UNITED STATES ENVIRONMENTAL PROTECTION AGENCY
REGION IX
75 Hawthorne Street
San Francisco, CA

Thank you for providing for review the *Draft Radiological Data Evaluation Findings Report for Parcels B and G Soil* ("Report"), Former Hunter's Point Naval Shipyard (HPNS), September 2017. The U.S. Environmental Protection Agency (EPA), the California Department of Toxic Substances Control (DTSC), and the California Department of Public Health (CDPH) have independently reviewed this report in detail with a technical team including national experts in health physics, geology, and statistics, and EPA's comments are attached.

EPA Review of Draft *Radiological Data Evaluation Findings Report for Parcels B and G Soil, Former Hunters Point Naval Shipyard, San Francisco, California, September 2017.*

EPA Comments dated December 2017

PARCEL B – TU 186

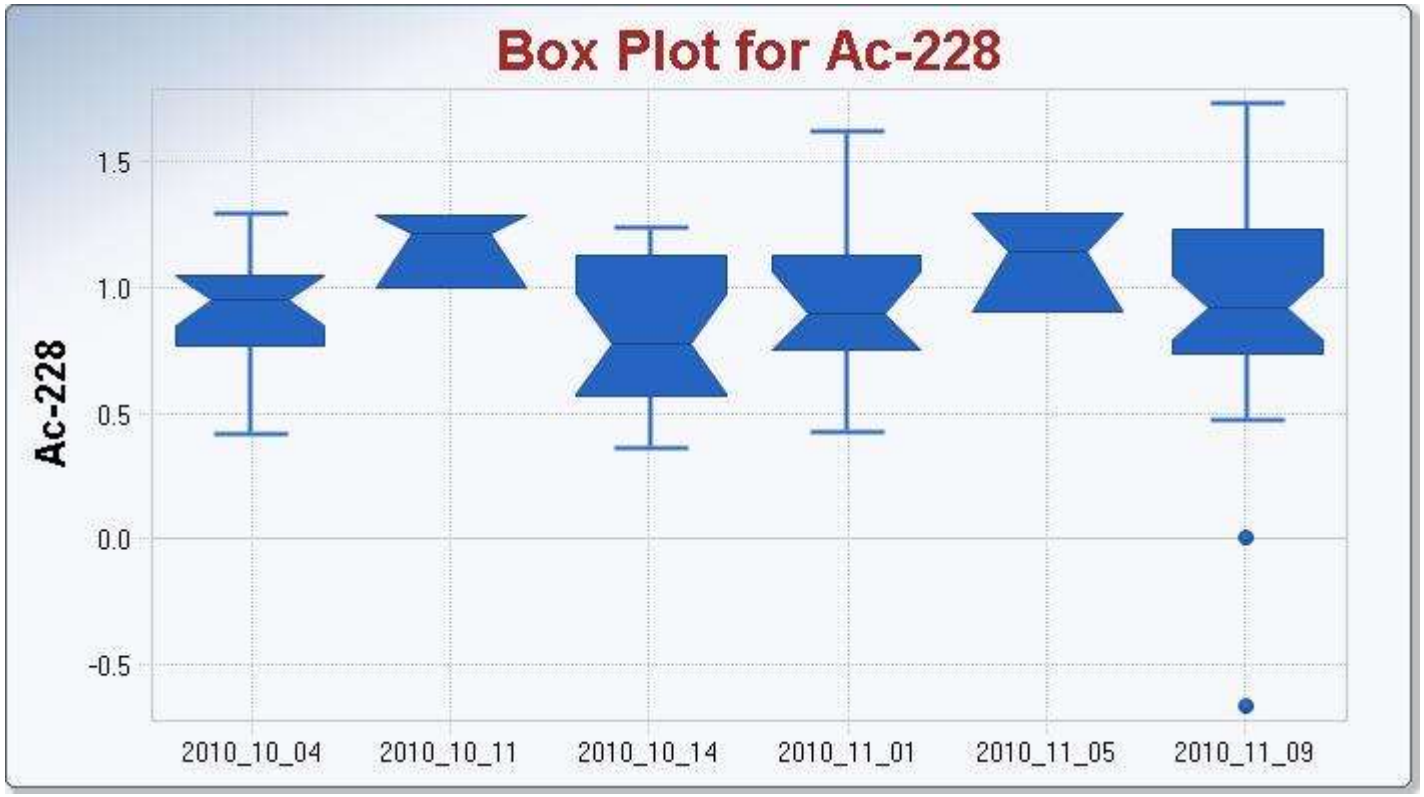
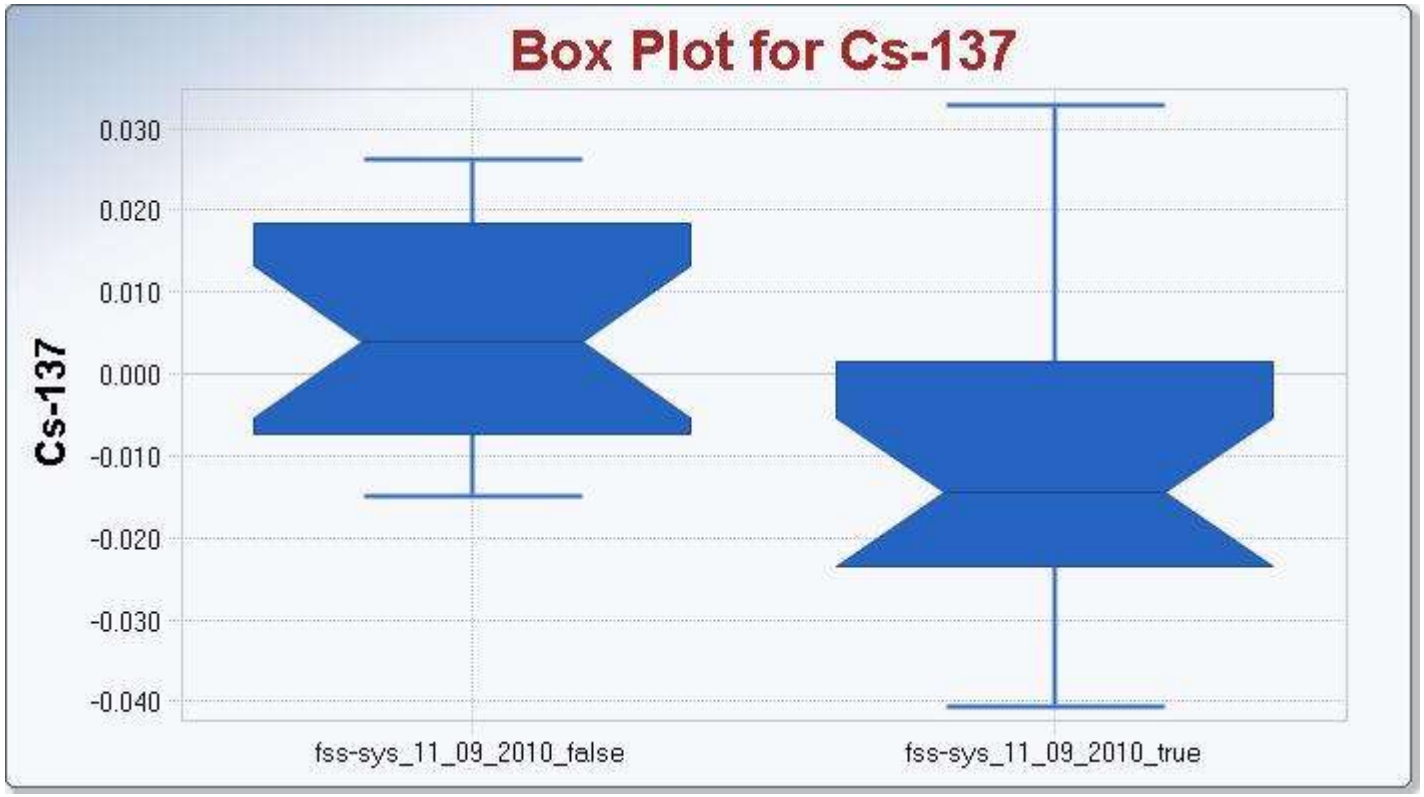
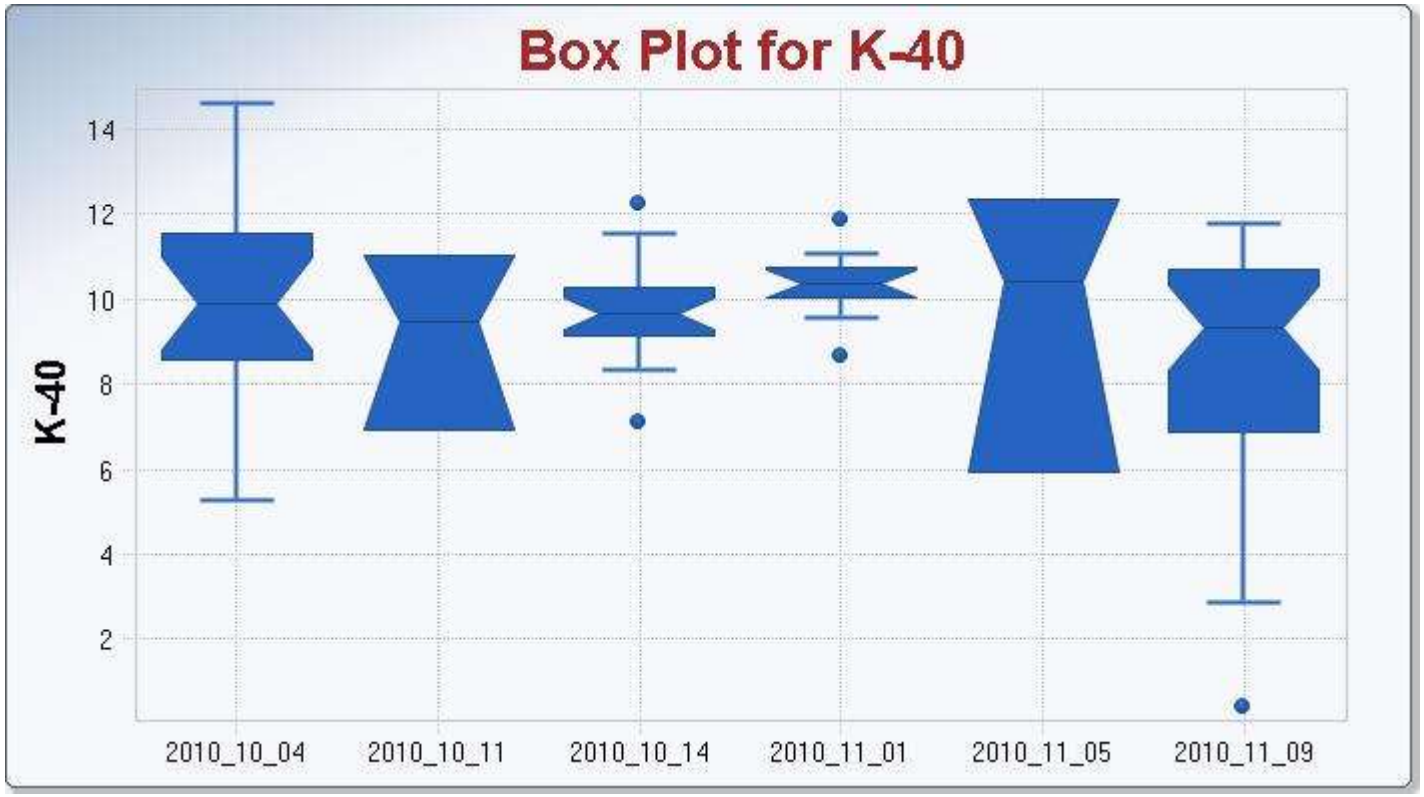
Note: Wide spread for 11/09/2010 – examining data shows 19 samples for on-site analysis and 19 samples for off-site analysis. Prompted me to explore the spread by breaking out the two types of analyses. Figure below shows the on-site analysis resulted in lower results explaining the presence of the spread in the plot above. The off-site analysis shows similar variability to the other 5 events.
